**Applications for
Permanent Encroachment
on Sidewalks for
Accessible Ramps**

HRM Accessibility Advisory Committee

**Applications for
Permanent Encroachment
5990 Spring Garden Road
and 1587 Dresden Row**

Proposed Entrance Elevation

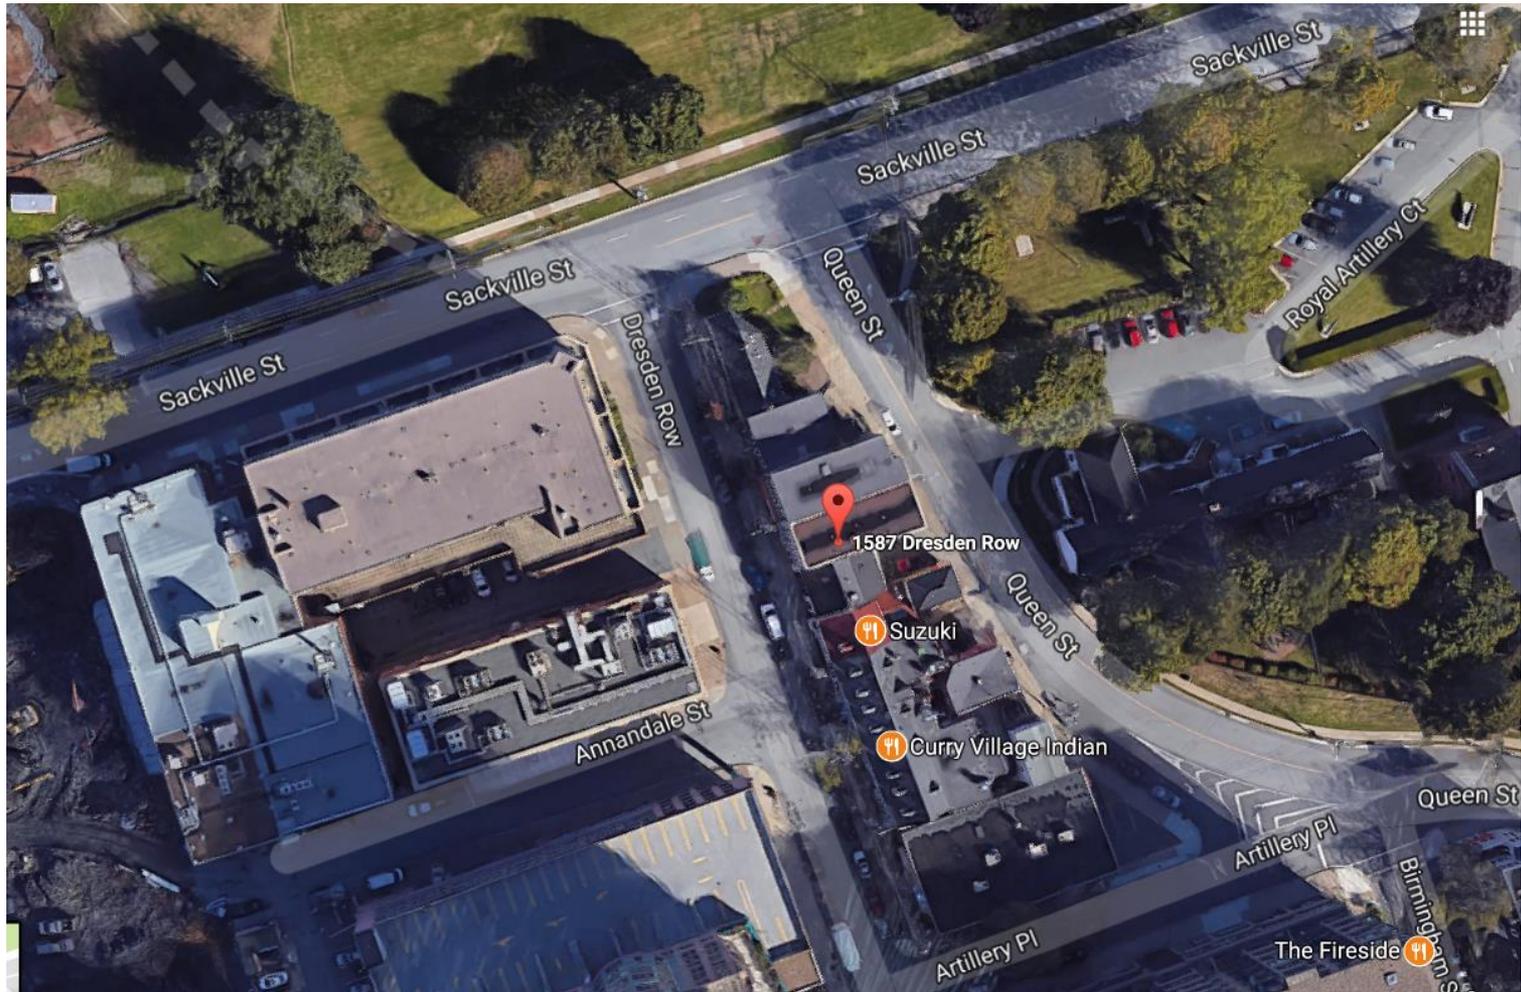
- 5.0 m existing sidewalk width
- 2.5 m remaining clearance left between edge of sidewalk and proposed accessible ramp
- Would allow accessibility to front entrance of commercial space
- Other sidewalk cafes exist along this road
- 2.1 m remaining clearance typically recommended to allow for accessibility

1587 Dresden Row

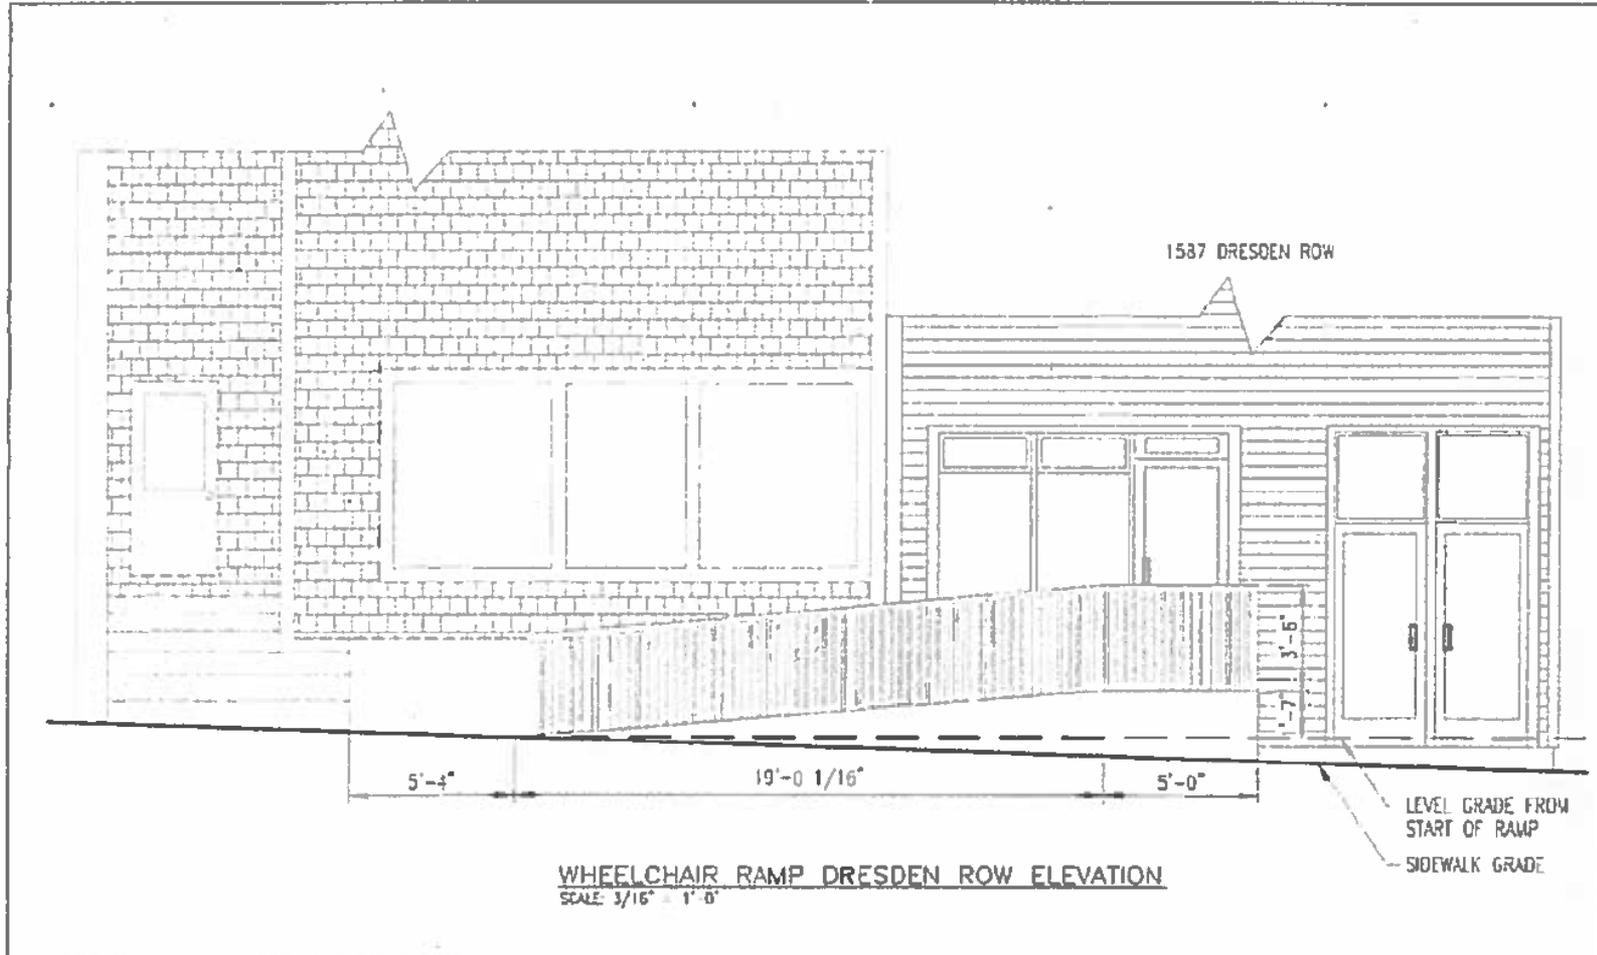
- 4.6 m existing sidewalk width
- 1.5 m remaining pedestrian clearance at “pinch point”, 2.1 m elsewhere
- Would allow accessibility to front entrance of commercial space
- Other sidewalk cafes common on this road
- Given the pedestrian volumes, configuration, and classification of Dresden Row as a local street, is the remaining clearance of 1.50 m (4.9 ft) at pinch point acceptable?
